Town of Wallingford, Connecticut

RE: Notification of Public Hearing – Special Permit Application #414-19
425 and 528 South Cherry Street

RE: Site Plan Application #414-19
425 South Cherry Street

TO: KACIE HAND, TOWN PLANNER
FROM: ERIK KRUEGER, P.E., SENIOR ENGINEER – WATER AND SEWER DIVISIONS *ERK*
SUBJECT: APPLICATION #414-19 - J. DEWEY – ONE BALL STREET LLC
SPECIAL PERMIT – WAREHOUSE & DISTRIBUTION CENTER
425 SOUTH CHERRY STREET
DATE: JANUARY 10, 2020
CC: N. AMWAKE, P.E.; T. SMITH; R.C. VANSKI; J. DEWEY, P.E., BL COMPANIES

GRAVITY SANITARY SEWER
 LATERAL INSTALLATION AT
 DEPTHS GREATER THAN 15'

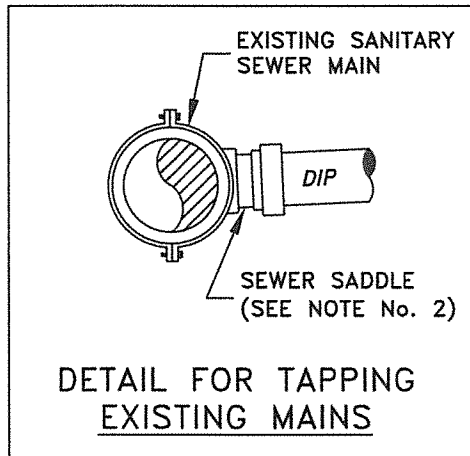
The note regarding the connection of the new sanitary sewer lateral to the deep sanitary sewer main shall be revised to include the following language, "If the existing chimney connection is not suitable for reuse, the lateral shall be connected directly to the existing main in accordance with the requirements shown on Sewer Standard Detail STS-18B", copy attached.

The note regarding the connection of the new sanitary sewer lateral to the deep sanitary sewer main shall be revised to include the following language, "If the existing chimney connection is not suitable for reuse, the lateral shall be connected directly to the existing main in accordance with the requirements shown on Sewer Standard Detail STS-18B", copy attached.

Response: The deep sanitary sewer main note and detail STS-18B will be added to the plans.

SCALE: N.T.S.	DATE: 3-27-2017	DRAWN BY: TF	SHEET NO. 1: 29	IDENT. NO. 1: STS-29
------------------	--------------------	-----------------	--------------------	-------------------------

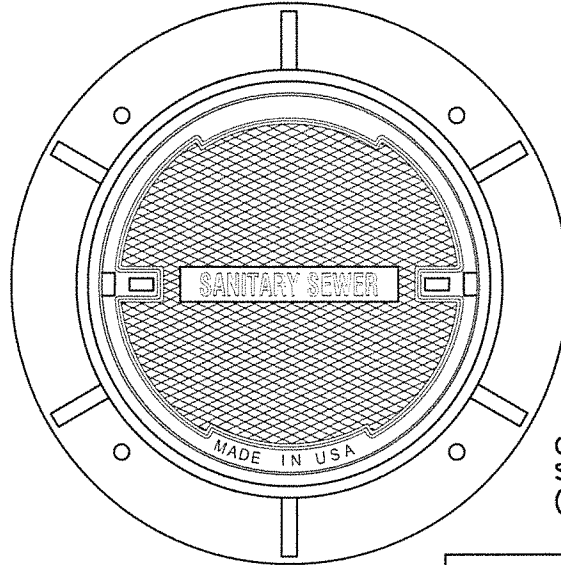
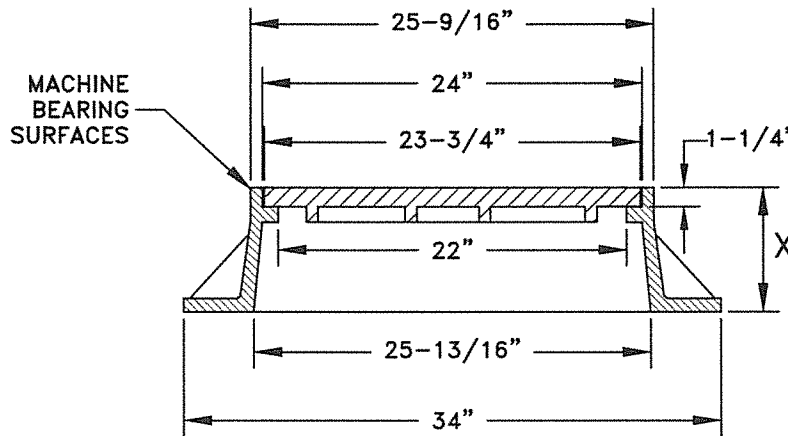
- d. A monitoring manhole is required to be installed on the sanitary sewer lateral near the street line. The manhole frame and cover detail shall be revised to reference Sewer Standard Detail STS-29 for private manholes, copy attached.

Response: The plans will be revised to include a monitoring manhole on the sanitary sewer lateral near the street line. The Wallingford standard detail STS-29 for private manholes will be included on the revised plans.

Project No.	425-01
Sheet No.	DN-6
Date	11/20/04
Scale	AS SHOWN
Author	WJG
Checker	WJG
Engineer	WJG

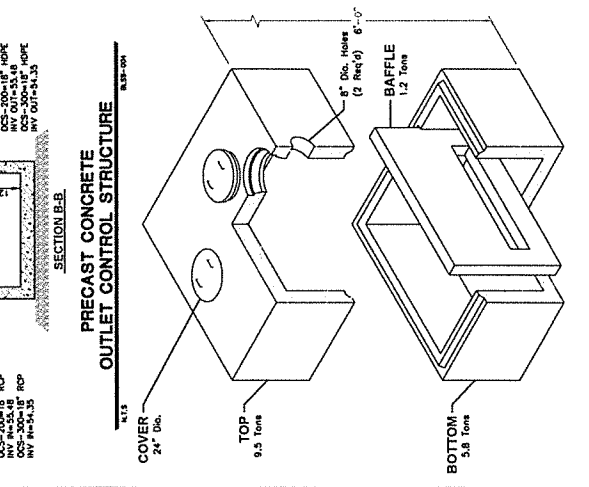
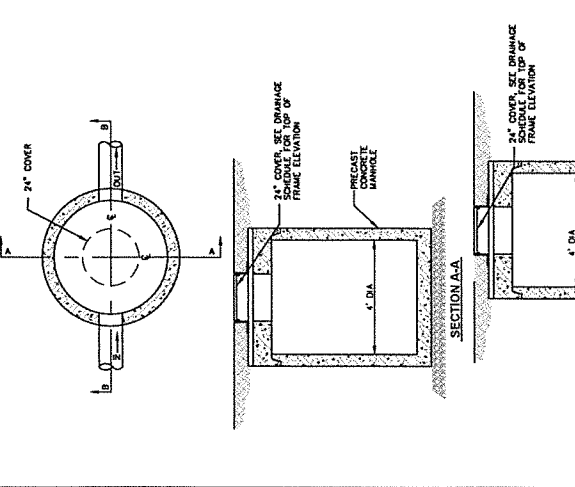
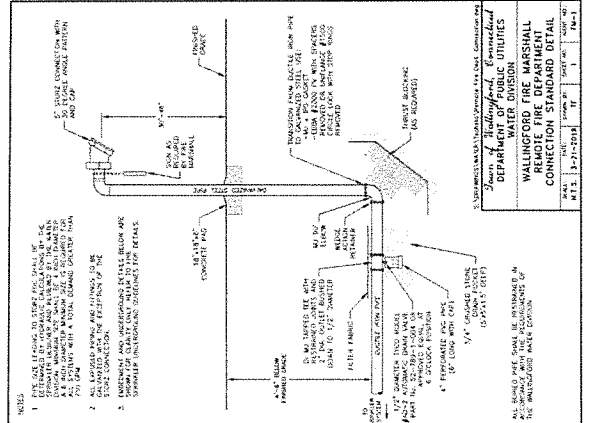
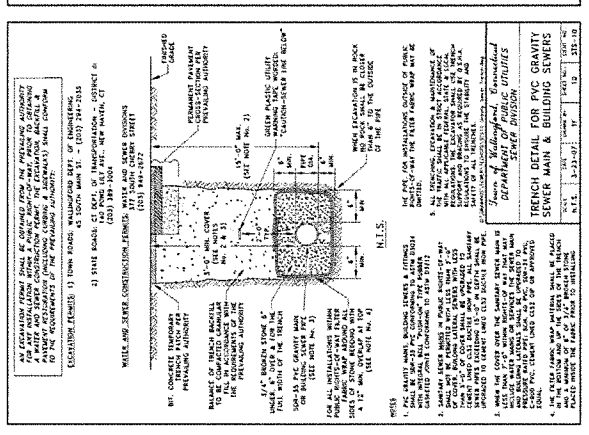
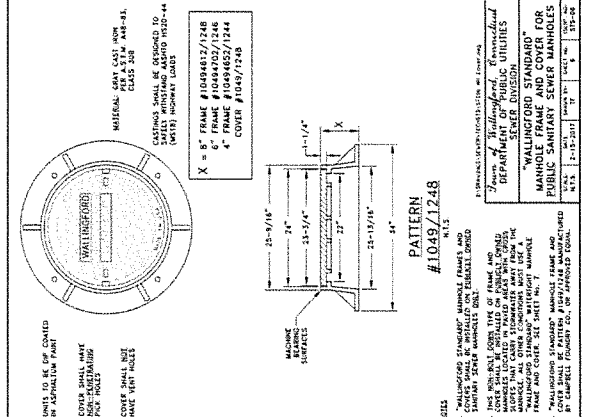
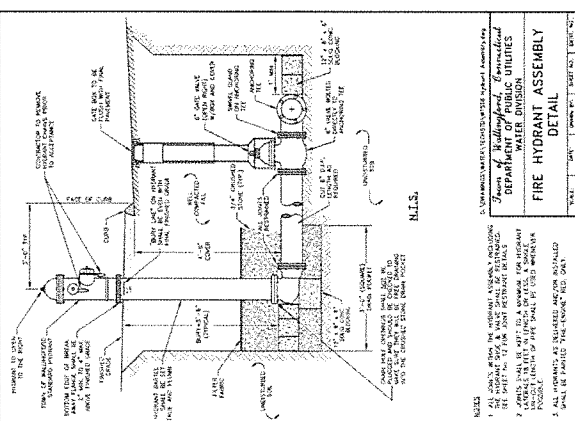
9. The water and sewer details shown on sheet DN-6 do not conform to the Wallingford Water and Sewer Divisions Technical Standards and Details. The details shall be revised to conform to the Wallingford Standards.

- a. The details of the oil-water separator shown on drawing DN-6 must be revised to show the Sewer Standard Detail STS-27 for Sanitary Sewer Oil/Water Separator Tanks, copy attached.
- b. The applicant will need to provide sizing calculations of the proposed oil-water separator for review and approval by the Wallingford Sewer Division.
- c. A wastewater discharge survey must be submitted and all pre-treatment devices and all necessary permits, including Connecticut Department of Energy and Environmental Protection discharge permit registrations, must be in place prior to discharge.
- d. A monitoring manhole is required to be installed on the sanitary sewer lateral near the street line. The manhole frame and cover detail shall be revised to reference Sewer Standard Detail STS-29 for private manholes, copy attached.

- a. The details of the oil-water separator shown on drawing DN-6 must be revised to show the Sewer Standard Detail STS-27 for Sanitary Sewer Oil/Water Separator Tanks, copy attached.

Response: The details of the oil-water separator will be revised to show the Wallingford Sewer Standard Detail STS-27.
